NUREG-1437
Supplement 55

Generic Environmental Impact Statement for License Renewal of Nuclear Plants

Regarding Braidwood Station, Units 1 and 2

Final Report

Figure 3–4. Braidwood Cooling Pond and Kankakee River Blowdown Line

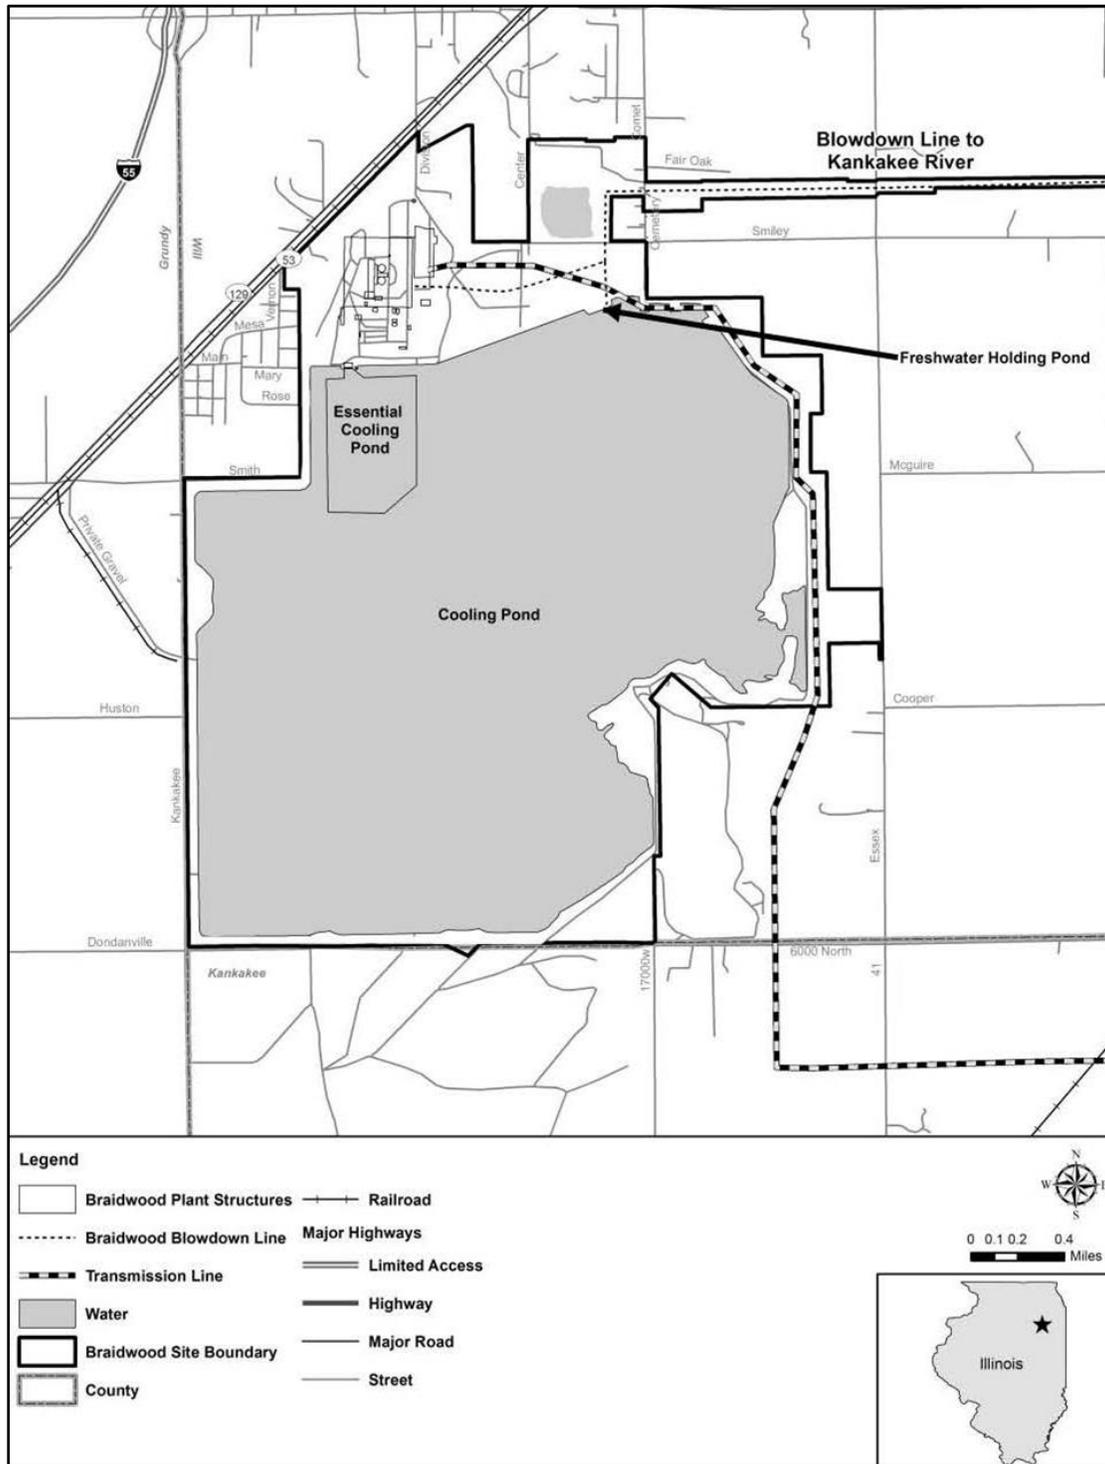
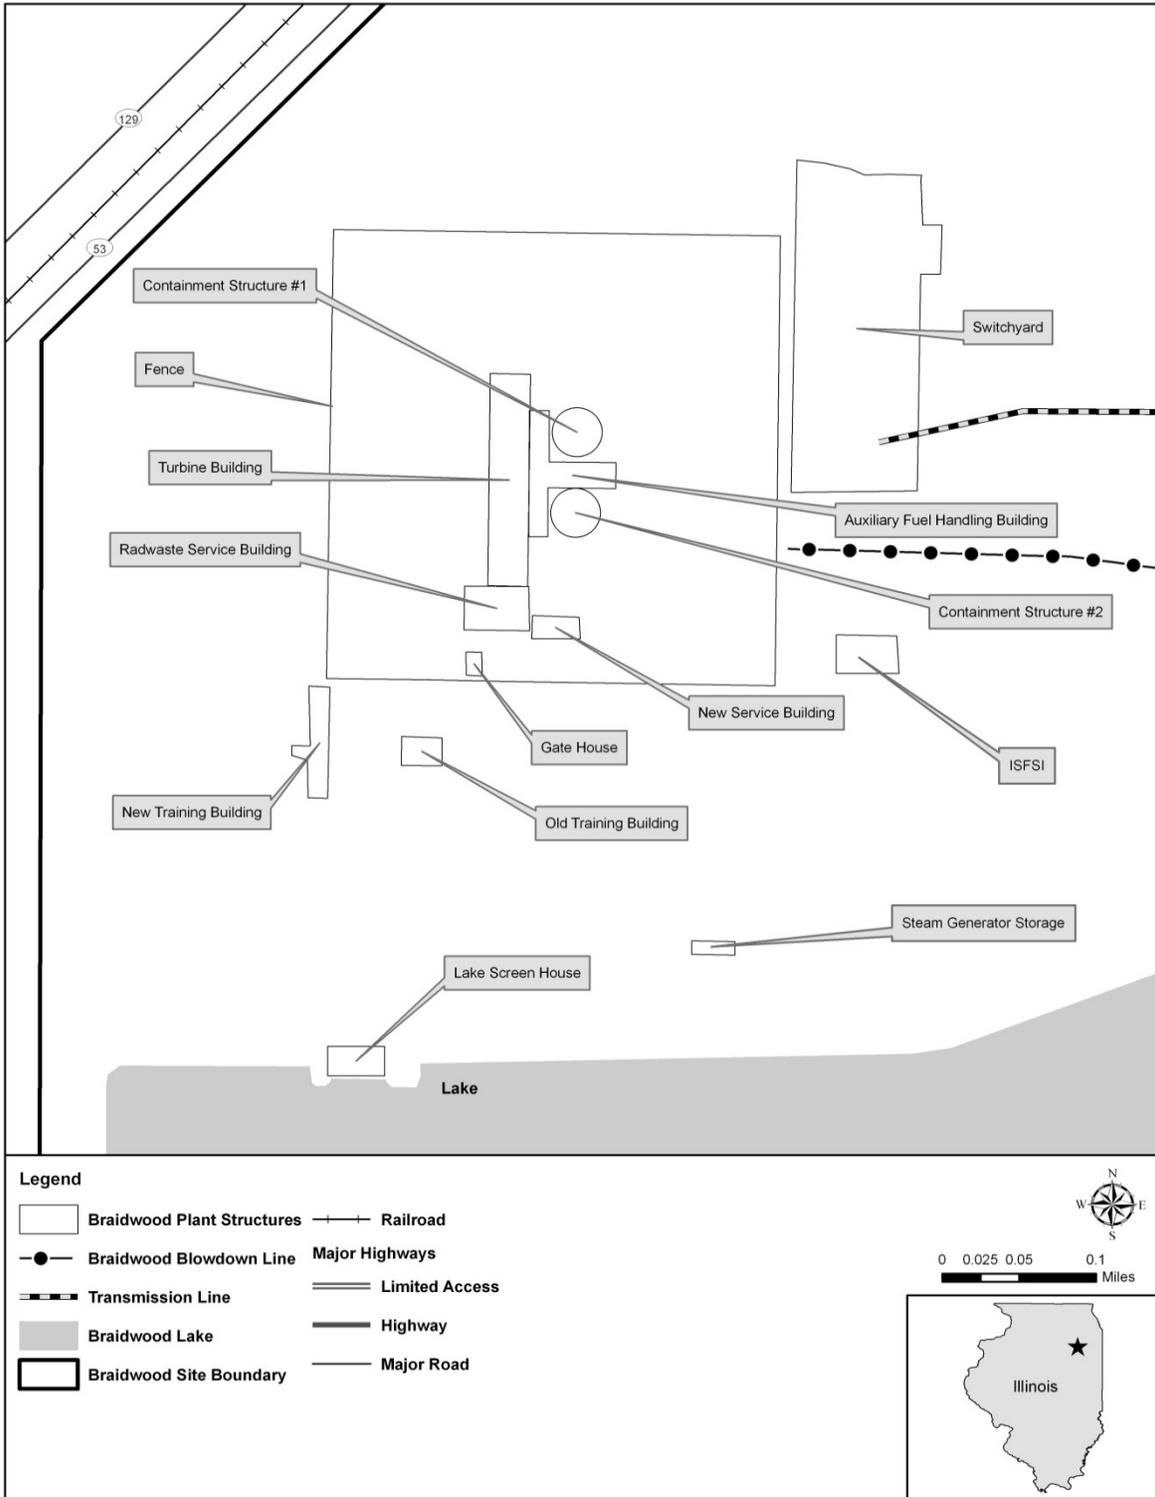
Comment 020-24-Affected Environment: Consider marking the makeup water pipeline on Figures 3-4 and 3-5.

Response: *Amending Figures 3–4 and 3–5 to show the makeup water pipeline does not impact the environmental analysis of the SEIS. Therefore, Figures 3–4 and 3–5 were not updated to show the water pipeline.*

Figure 3–16. Comparison of Relative Abundance of Most Prevalent ^(a) Fish Families in Historic and Recent Kankakee River Monitoring Samples

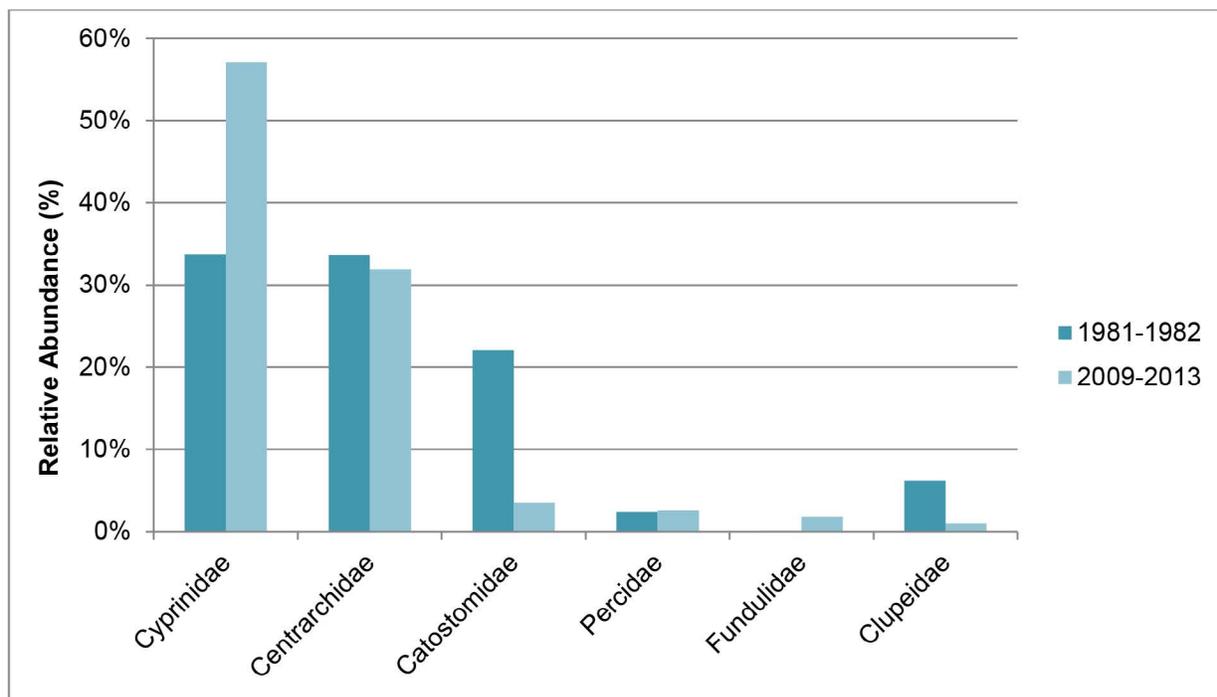
Comment 019-5-Aquatic: The comparisons in Figure 3-16 (histograms) are based on data in Table 3-10, which is fundamentally flawed: species were assigned to wrong families, thus aggregate number collected by family is wrong in almost every case. Consider revisiting and revising such comparisons after correcting the data.
